Restaurant at 8100 Wyoming Boulevard

Administrative Amendment Request

Project #PR- 2021-005547

Transportation Development Comments:

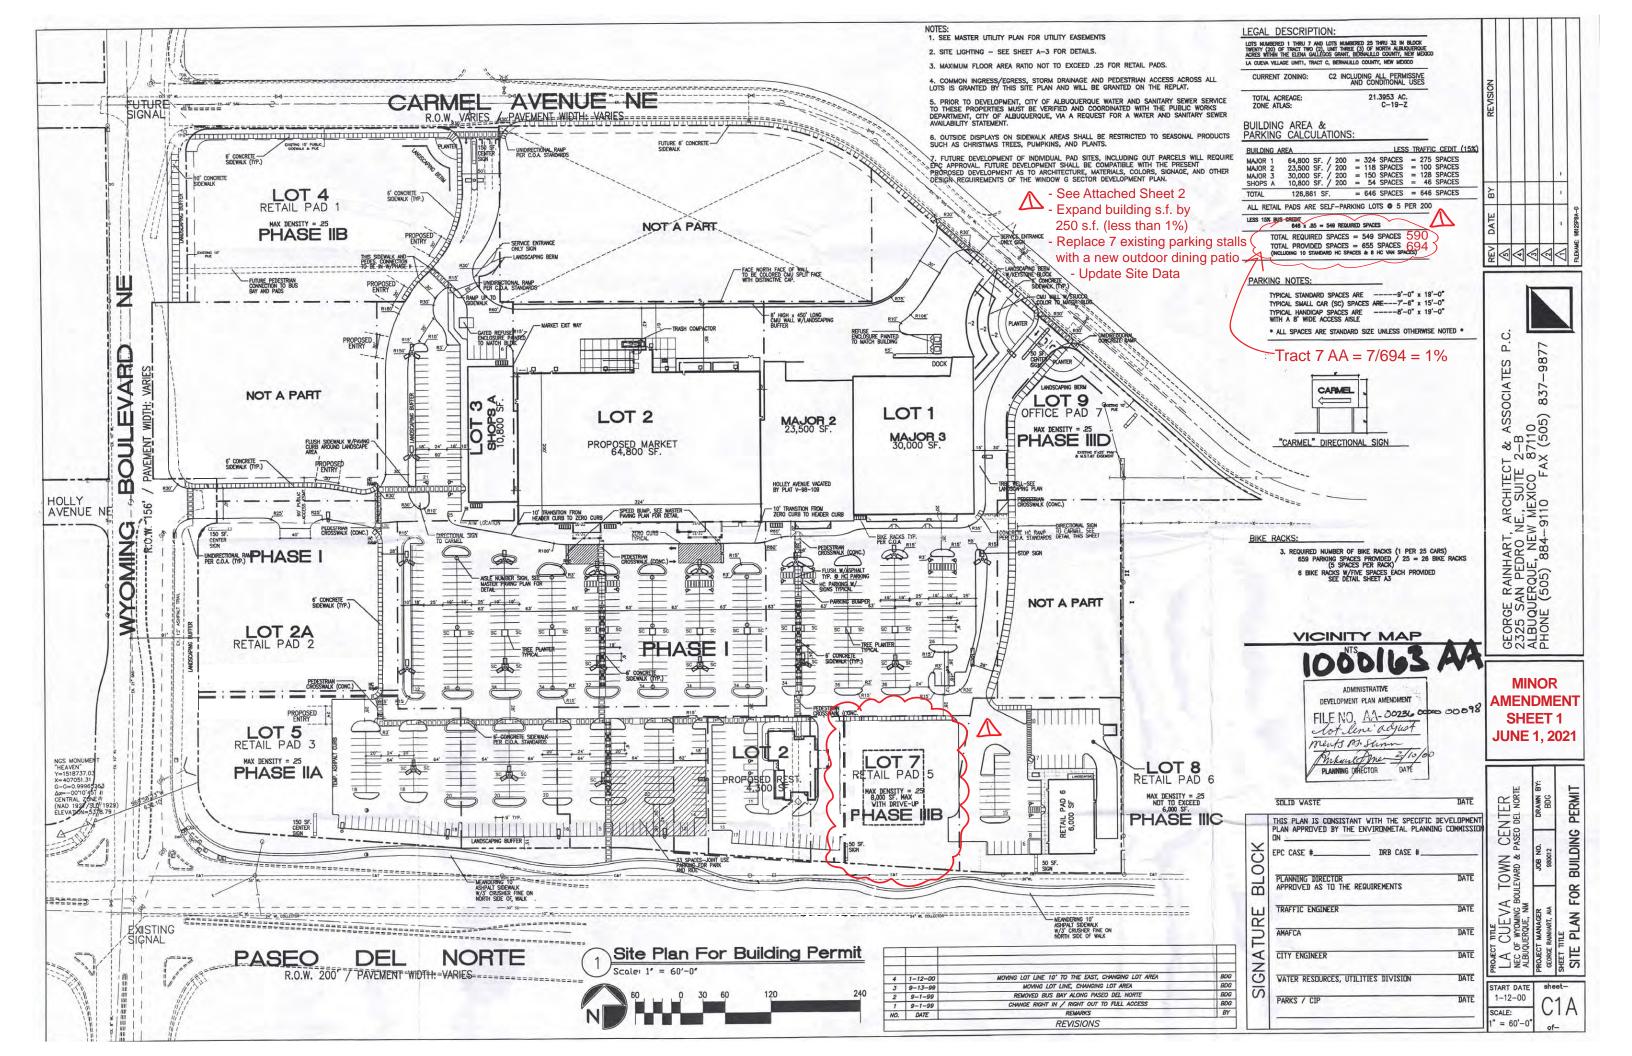
- 1. For parking calculations, also account for the outdoor seating per IDO requirements. Provide Shared Parking Agreement as needed, and adjust ADA parking as needed.

- 2. Due to the 250 square foot building addition, verify adequate ADA access from the existing van accessible aisle. Provide information on existing curb ramp, and provide a dimension for the turning space behind the curb ramp to ensure at least a 4-foot wide turning space.

- 3. Provide a bike rack and motorcycle parking per new IDO requirements. Add details as necessary for the rack and signage. Label "MC" at back of the parking space for the motorcycle parking.

- 4. The ADA access aisle shall have the words **"NO PARKING"** in capital letters, each of which shall be at least one foot high and at least two inches wide, placed at the rear of the parking space so as to be close to where an adjacent vehicle's rear tire would be placed. (66-1-4.1.B NMSA 1978)

- 5. The ADA accessible parking sign must have the required language per 66-7-352.4C NMSA 1978 "Violators Are Subject to a Fine and/or Towing." Add this detail.
